# Historic Preservation Board File No. 25-0676

## 2201 Collins Avenue

UPDATED Presentation by Law Offices of Kent Harrison Robbins, P.A.  
on behalf of the Roney Palace Condominium Association, Inc.

April 14, 2026

TUNNEL CONFIGURATION EXHIBIT  
SCALE: 1" = 40'-0"

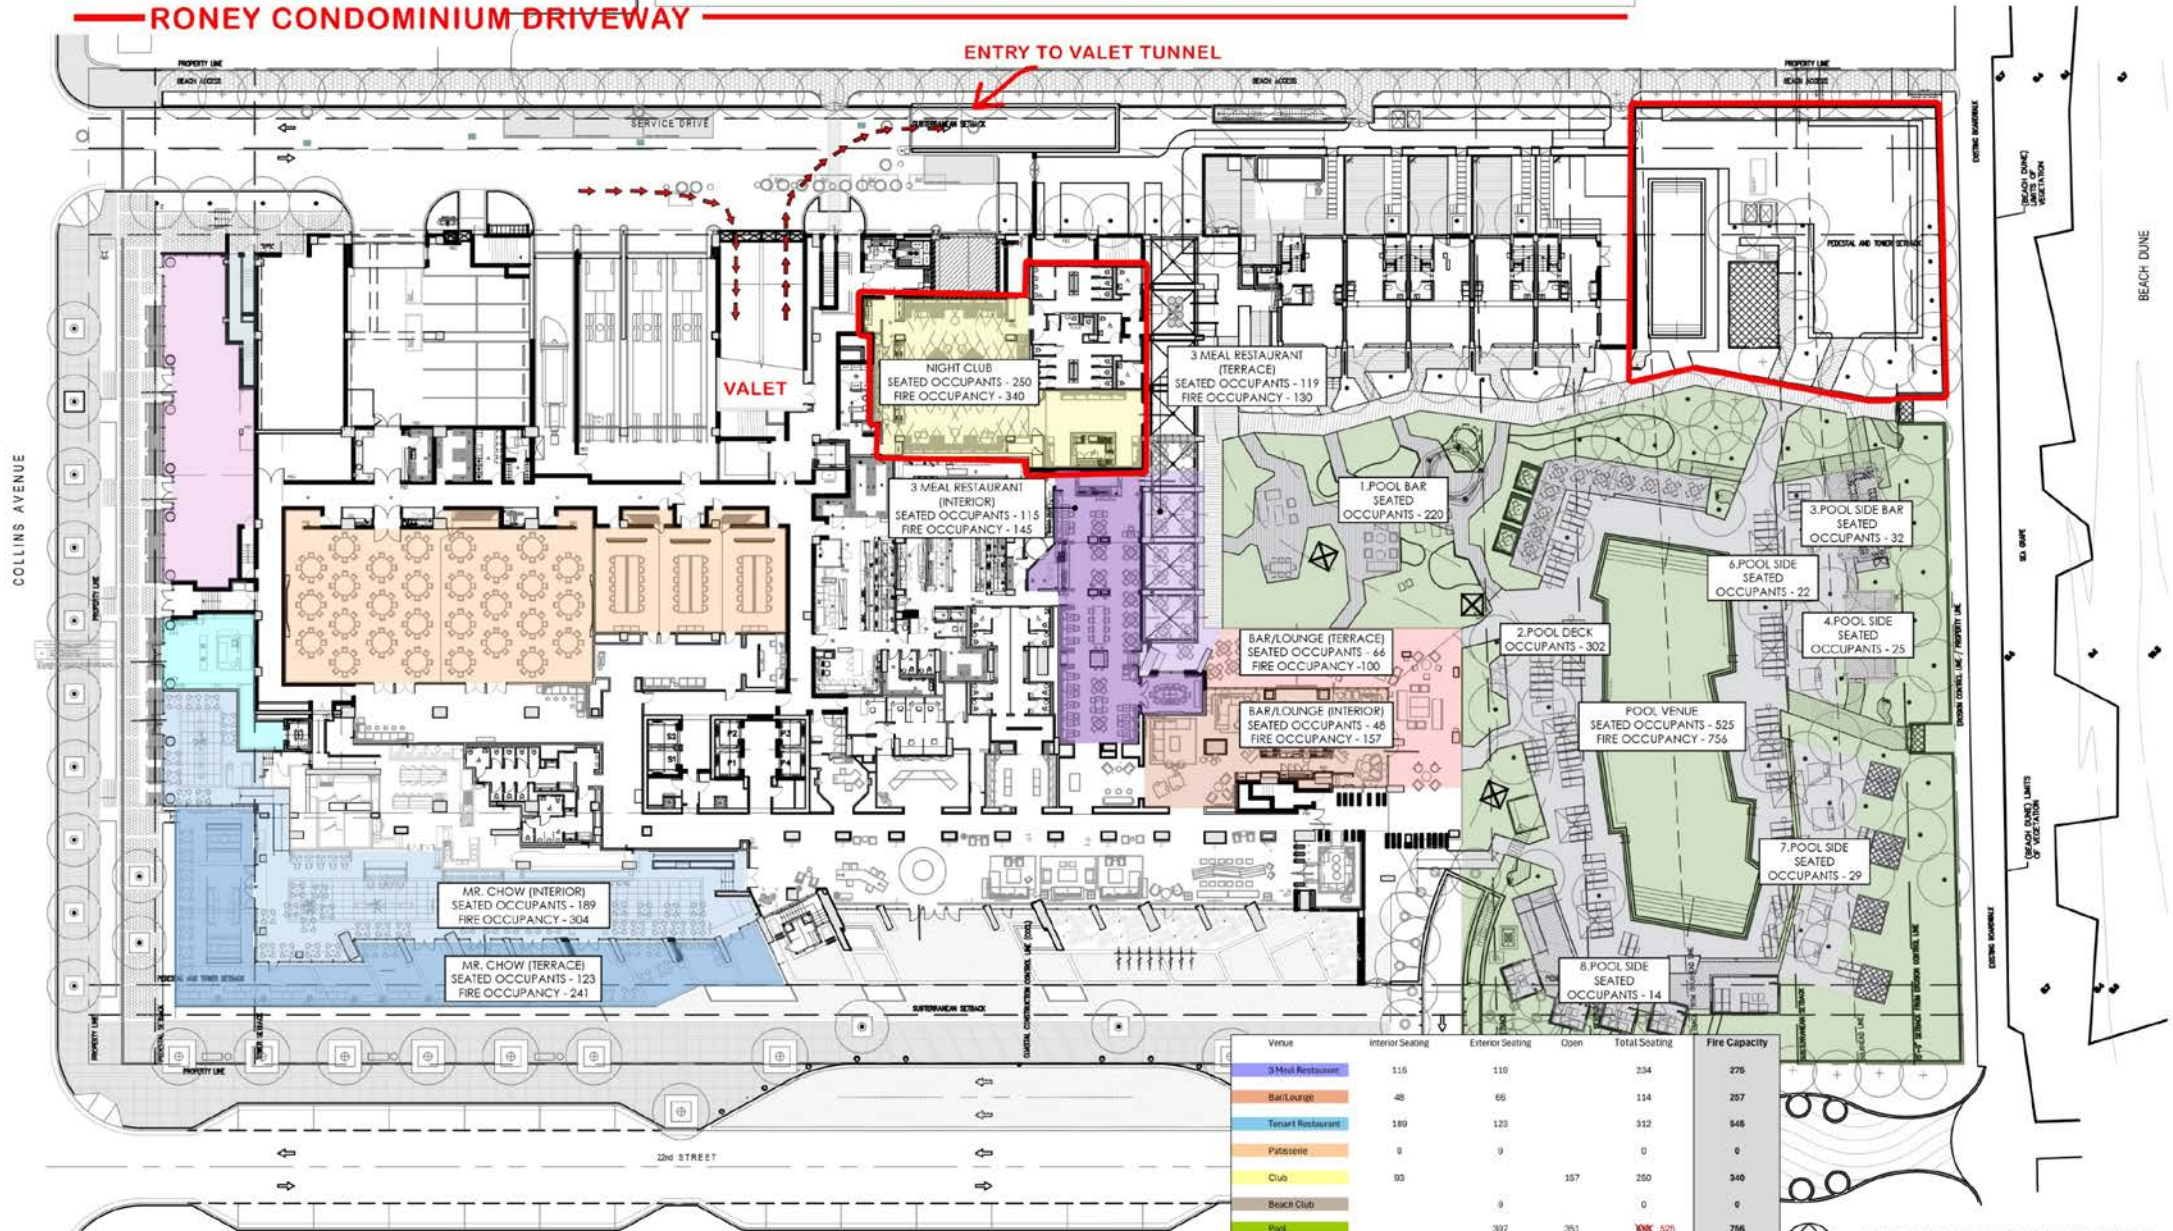
# VALET TUNNEL

## Entry West End of 23rd Street Driveway

PROPOSED CONDITIONAL USE PERMIT  
SCALE: 1" = 40'-0"

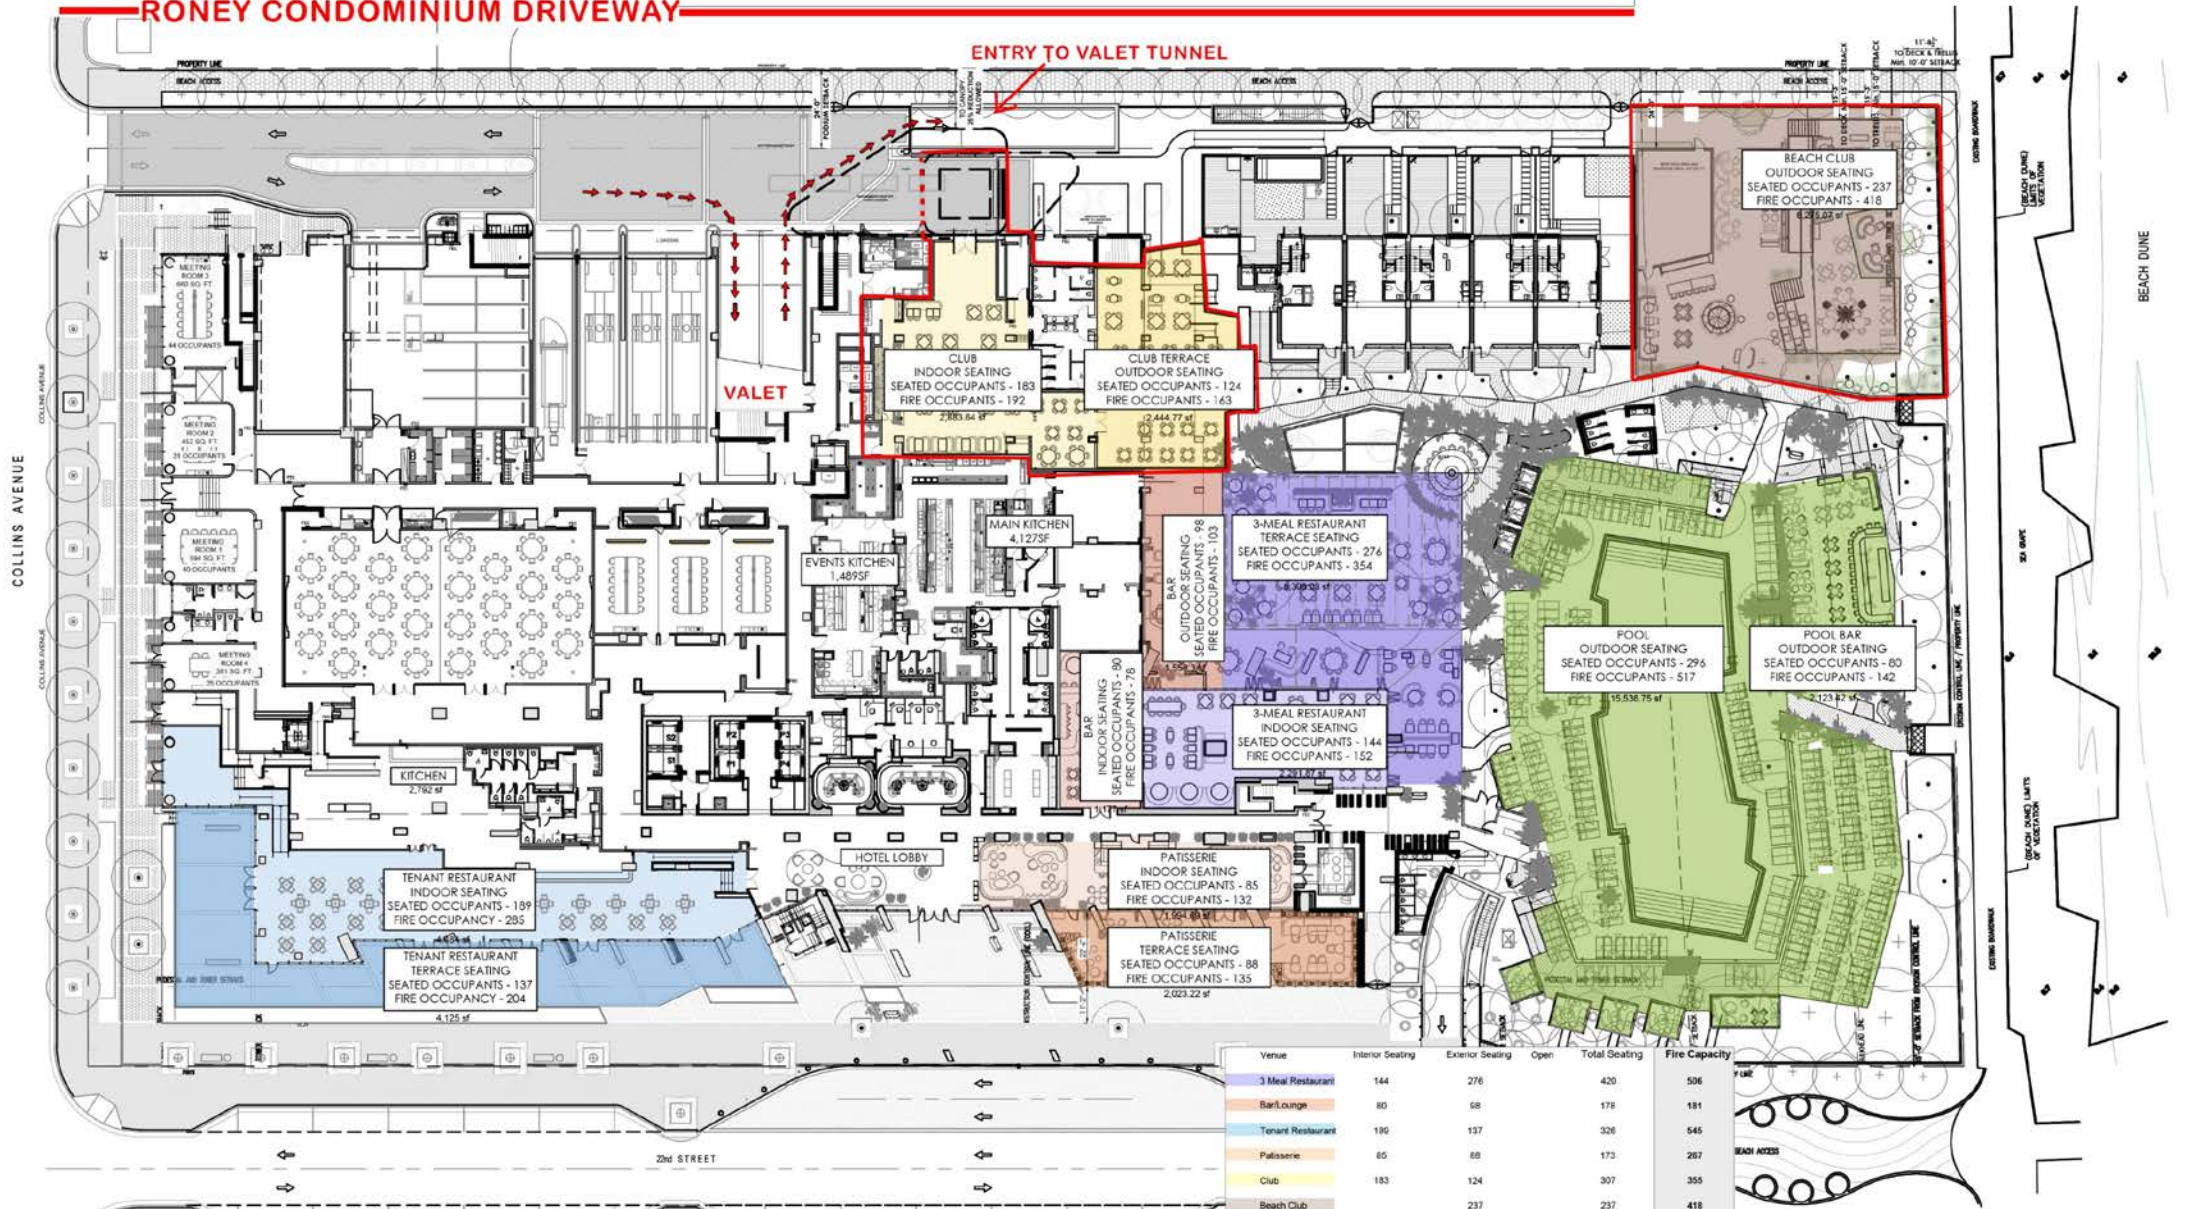
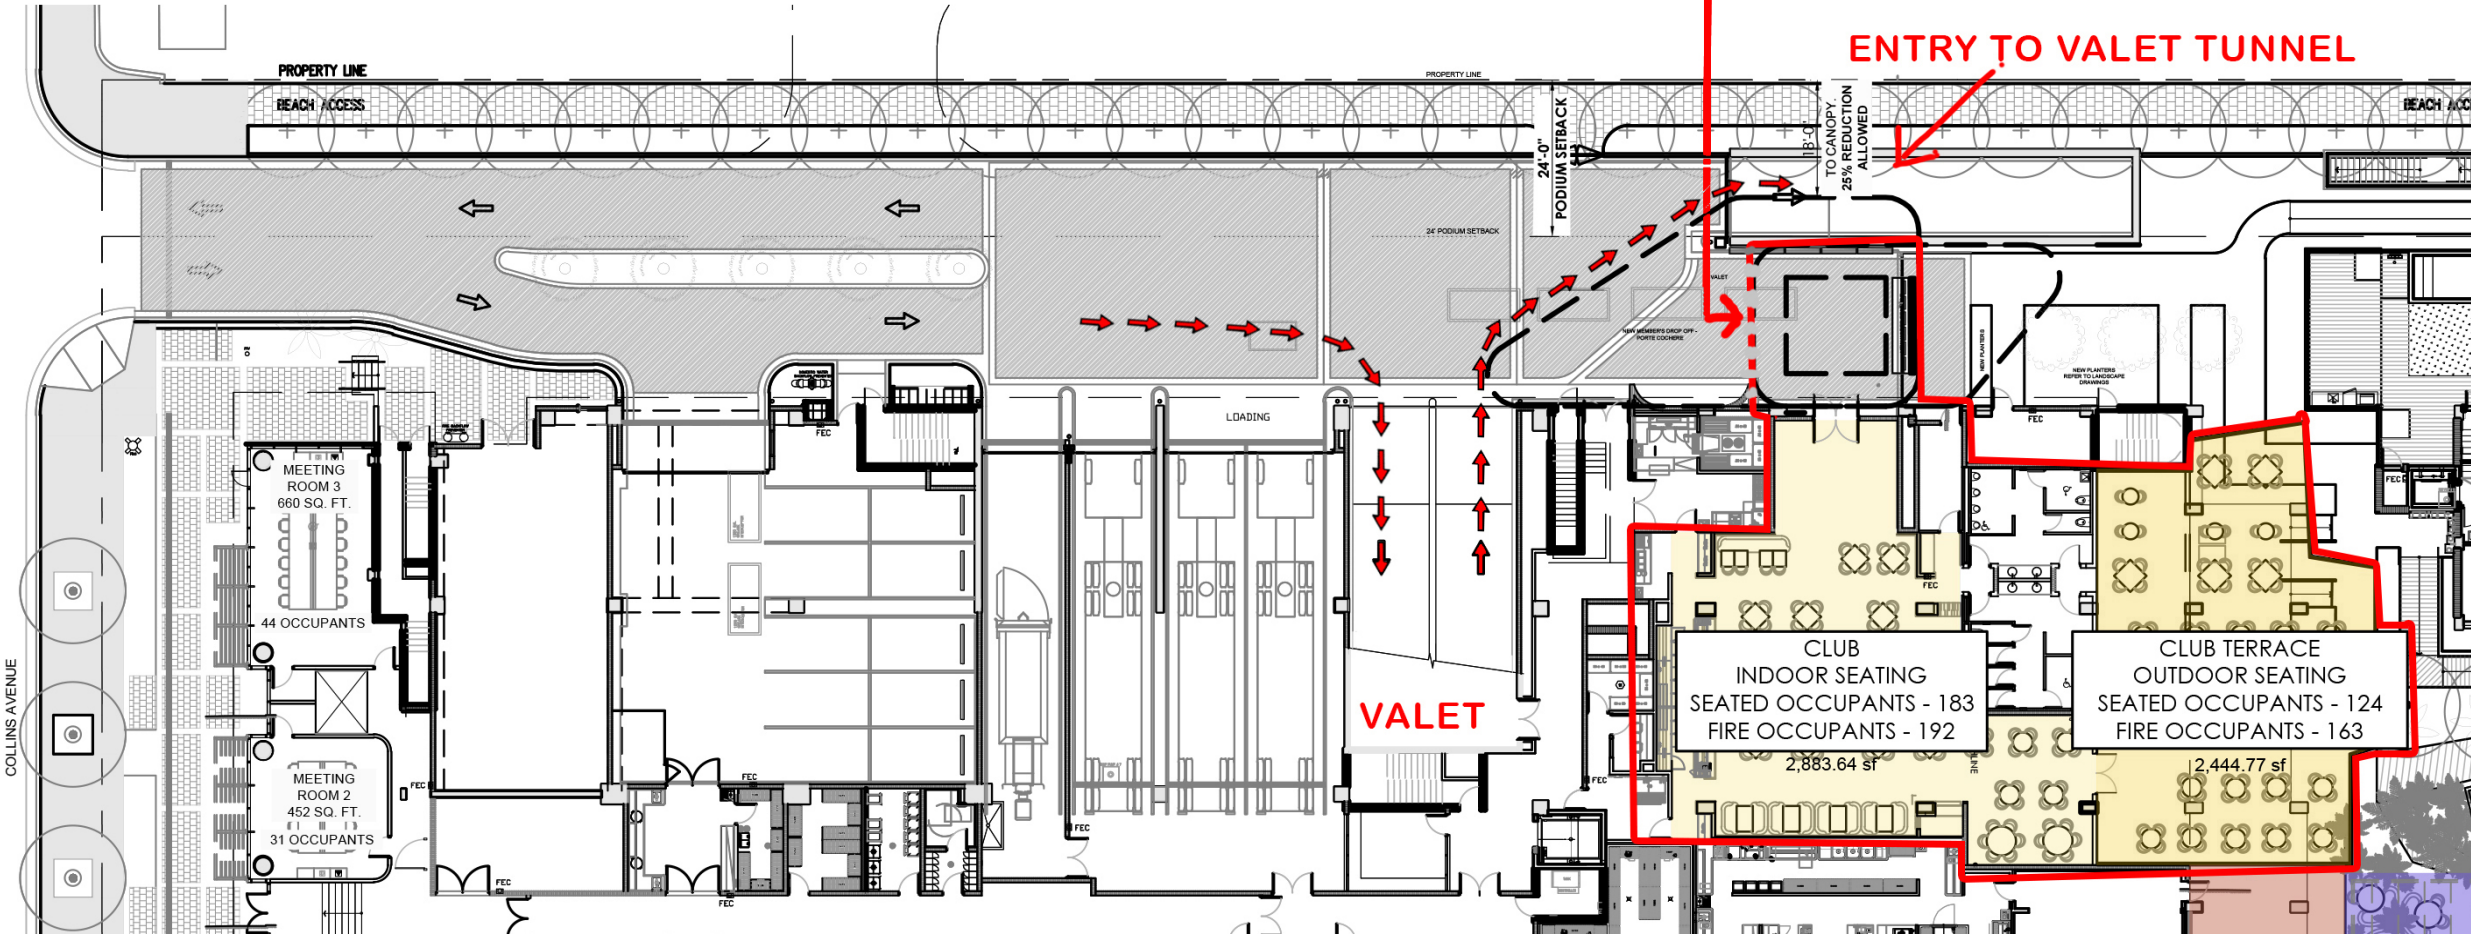
**Key issue:** Although the seat count appears similar, the proposed outdoor terrace is **entirely new construction (2,482 sq ft wood deck)** on the north side of the property, directly adjacent to the Roney driveway. The existing outdoor seating was in a different location and configuration. This is a new noise source, not a continuation of existing conditions.

The proposed new valet stand on the North Driveway (23rd Street)

Guest and ride-sharing vehicle access to the North Driveway for drop-offs

**NEW NIGHTCLUB  
DROPOFF / PORTE COCHERE**

**ENTRY TO VALET TUNNEL**

*“The Planning Board shall also consider and impose conditions governing: (a) the proposed new valet stand on the North Driveway; and (b) guest and ride-sharing vehicle access to the North Driveway for drop-offs.”*
